**CITY PLAN COMMISSION****THURSDAY, SEPTEMBER 5, 2024****FILE NUMBER:** S234-180**SENIOR PLANNER:** Hema Sharma**LOCATION:** Hall Street and Roseland Avenue, east corner**DATE FILED:** August 8, 2024**ZONING:** PD 298 (Subarea 1)**PD LINK:** <https://dallascityhall.com/departments/city-attorney/Articles/PDF/Article%20298.pdf>**CITY COUNCIL DISTRICT:** 14**SIZE OF REQUEST:** 0.302-acres**APPLICANT/OWNER:** The Hall Street Yankee, LLC

**REQUEST:** An application to replat a 0.302-acre tract of land containing all of Lots 15 and 16 in City Block 596, and part of City Block 596 to create one lot on property located on Hall Street and Roseland Avenue, east corner.

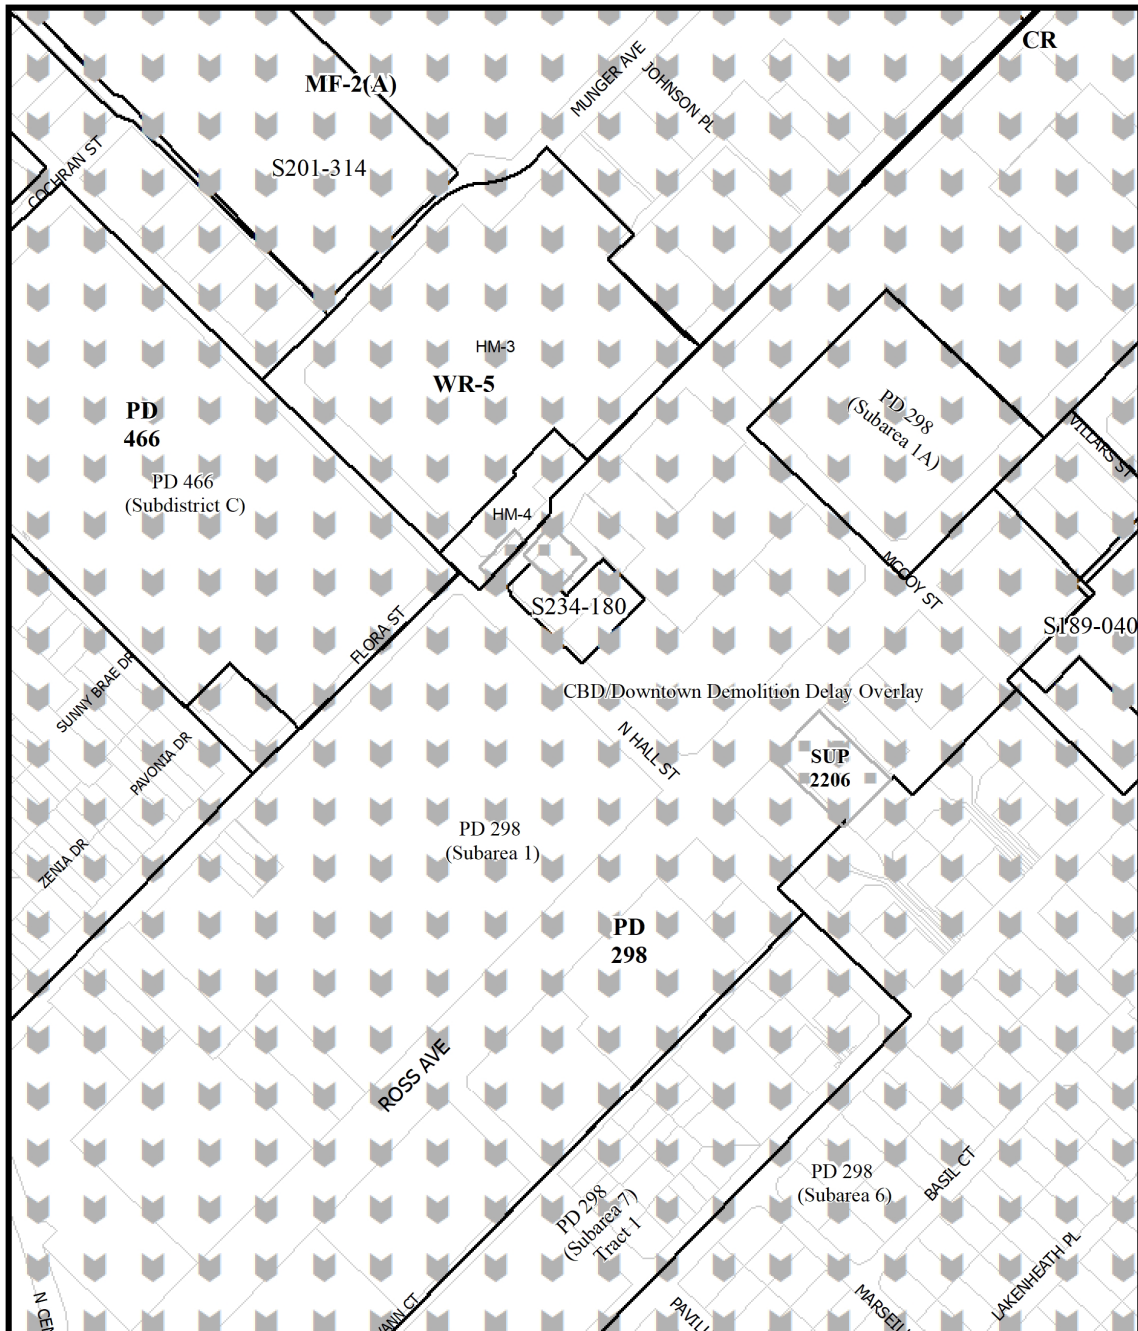
15. On the final plat, dedicate 25 feet of right-of-way (via fee simple) from the established center line of Hall Street. *Section 51A 8.602(c)*
16. On the final plat, dedicate 28 feet of right-of-way (via fee simple or street easement) from the established centerline of Roseland Avenue. *Sections 51A-8.602(c), 51A-8.604(c) and 51A-8.611(c).*
17. On the final plat, dedicate a minimum 5-foot by 5-foot corner clip (via fee simple or street easement) at the intersection of Hall Street & Roseland Avenue. Section 51A 8.602(d)(1)
18. A larger corner clip may be requested during engineering plan and traffic review to accommodate an adequate turning radius, or to maintain public/traffic appurtenances, within the area of the corner clip. *Section 51A 8.602(d)(1), 51A 8.608(a)*

20. Prior to final plat, submit a completed final plat checklist and all supporting documents.
21. On the final plat, show how all adjoining right-of-way was created. Section 51A-8.403(a)(1)(A)(xxii).
22. On the final plat, show distances/width across all adjoining right-of-way
23. On the final plat, show recording information on all existing easements within 150 feet of the property.
24. On the final plat, list utility easements as retained within street abandonments when stated in the abandonment ordinance or follow the City of Dallas standard affidavit requirements.

28. Remove indented on-street parking unless redesigned to comply with City Standards and sufficient sidewalk is dedicated.
29. Prior to the final plat, please show the abandonment on the plat as follows: Abandonment authorized by Ordinance No.\_\_\_\_\_, recorded as Inst. No. \_\_\_\_\_. Utility Easements retained. If abandonment (Log 53895) not approved, fence encroaching in ROW adjacent to Hall Street must be removed.
30. On the final plat, identify the property as Lot 15A in City Block A/596.
